الموضوع: إشعار بمتابعة جهاز طبي Vascular Grafts, Biplex vascular grafts and Biplex Biovalsalva conduits

URGENT FIELD SAFETY NOTICE

Name of product affected: Biplex vascular grafts and Biplex Biovalsalva Conduits (stentless and stented)

FSCA identifier: CAPA 167

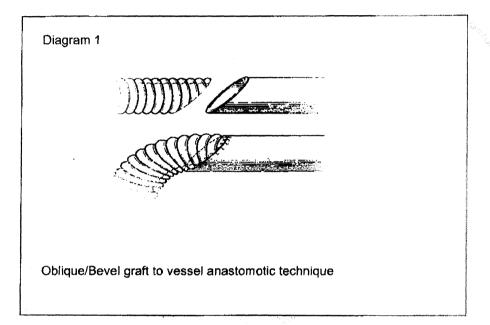
To reduce the risk of bleeding, Vascutek advise that clinicians are aware of an additional 5 cautions relating to sizing and insertion instructions:

- It is essential that the sutures are tightened each time they are passed through the material.
- In order to achieve a smooth suture line and good haemostasis, it is important that the graft diameter 2. selected must not be oversized relative to the distal anastomotic site.
- Care should be taken not to apply excessive tension at the distal anastomosis by ensuring the graft is cut to the correct length.
- The use of haemostatic agents/ accelerants and/or felt/ pledgets may reduce the incidence of suture line bleeding and restemotomy.
- The use of an oblique/ bevel graft to vessel anastomosis is recommended. This technique will minimise any blood leakage arising from the oversizing of the graft relative to the native vessel (see Diagram 1)
